**Title:** Committee Site Plan

**Reference:** 0764/15

**Site:** Land on the west side of Broad Road, Bacton

**Project:** Broad Road, Bacton (Planning Ref: MS/0764/15)      **Job No:** IT1527  
**Subject:** Off Site Highway Improvements: Additional Information  
**Prepared by:** Chris Glegg      **Date:** 14/08/2015  
**Checked by:** Justin Bass      **Date:** 17/08/2015

IT Project		BROAD ROAD, BACTON	
Rev:	B	Sign Amendment	4.8.15
A		Revised section labels & extended OS Map	30.1.15
Rev:	B	Description	Date
Drawing No:	IT 1527/SK/03	GAO File:	IT1527_SK_01.dwg
Date:	JUL 2015	Scale:	1:500 (unless stated)
Client:	MRS C ABBOTT	Drawn by:	EC
		Approved by:	SW

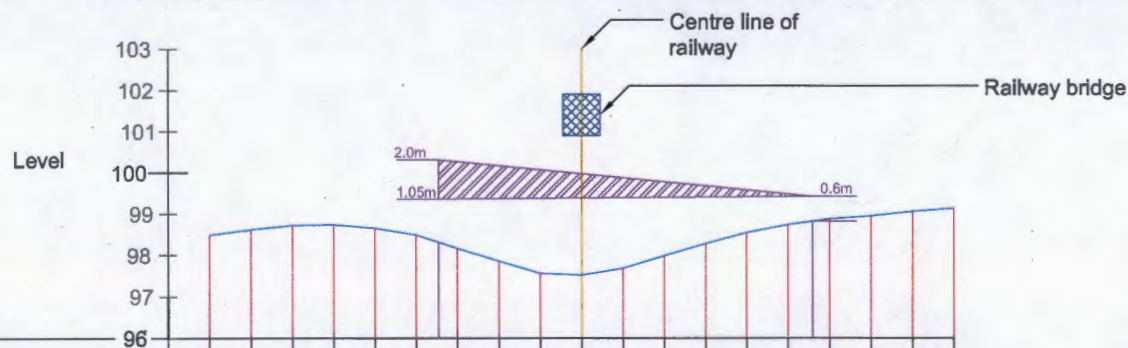
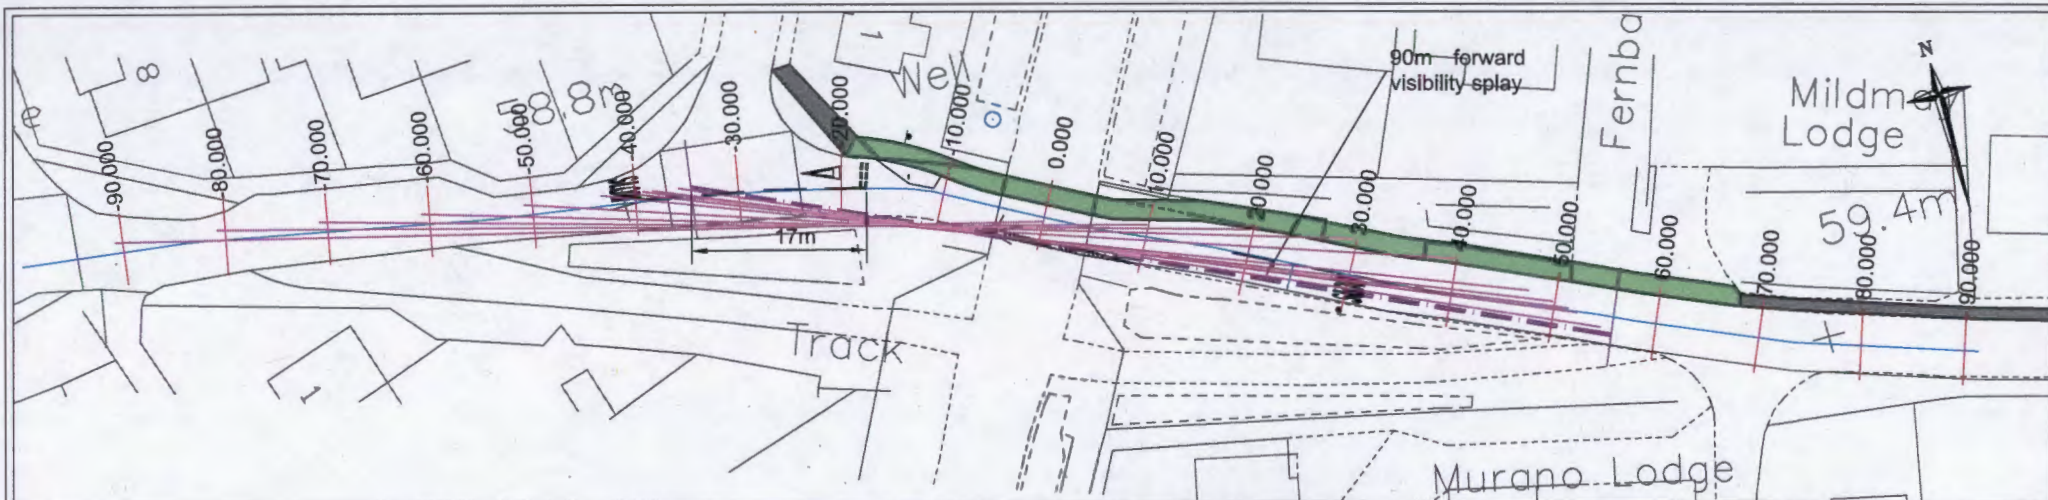
The drawing provided shows the provision of either bollards or P4 railings on the 2m wide footway adjacent to the northern bridge abutment. It is not clear if these are to be set at the rear of the footway or kerbside. In either case if provided kerbside they must be 450mm from the edge of the kerb thereby reducing the available width for pedestrians and mobility scooter users to 1.55m. Studies find that pedestrians and other footway users tend to move away from walls, railings and bollards which will reduce the available width, this in collaboration within the 1.55m available space will not provide sufficient footway space.

The Audit Team note that the location of the existing westbound 'SLOW' road marking shown on the drawing is too far to the west and is in fact adjacent to the maintenance track opposite property named 'Mildmay Lodge'. This may impact upon the design location of the 'Priority working' road sign as it could cause an obstruction to maintenance vehicles (See photo below).

In addition to the footway connection to the village centre, as shown on the applicant's drawing no. IT1527/SK03 Rev B, the site layout must incorporate a footway along the site frontage. This will improve highway safety as the new footway will highlight to drivers that there is a change in character of the road and this is likely to result in a reduction in vehicles speeds. In addition, our Street Lighting Team have indicated that street lighting will be required from the new estate to the junction with Pound Hill which will reinforce the change in nature of Broad Road and assist in reducing speeds.

1.  
No dwelling shall be occupied until the proposed footway connection to the village centre and associated priority system as shown on drawing no. IT1527/SK/03 Rev.B having been revised as required by the Highway Authority has been provided in accordance with details which previously shall have been submitted to and approved in writing by the Local Planning Authority.

<b>Audit Reference</b>	<b>Accepted (Y/N)</b>	<b>Comments</b>
2.2	Y/N	Whilst it is possible achieve a minimum acceptable width of 1.55m for the short section of footway under the bridge, the issue of having the railway bridge abutment wall at the back edge of the carriageway is noted. We consider that the detailed design could afford to reduce the carriageway width under the bridge to 3.4m and also the build out on the south side of the bridge to 0.45m. This would allow a clear footway width (including railing) of 1.7m under the bridge which should be regarded as an acceptable compromise to address a very dangerous situation at present of mixing pedestrians with vehicles in a live carriageway, particularly in dark and inclement weather conditions. Moreover, it is to be noted that part of the existing footway infrastructure on the approach to the bridge is only 1.2m wide; also in other parts of the village the footway is less than 1.55m. We however, concur with the Auditor that this is a matter for further discussion with the Highway Authority to agree the best geometric design at detailed design stage.

2.3	Y	The position of the 'SLOW' marking and the priority one way working sign is a matter that can be further refined at detailed design stage to ensure that there are no conflicts with the maintenance entrance to Network Rail's land. The position of the sign shown on the drawing appears to avoid such conflict in any event.
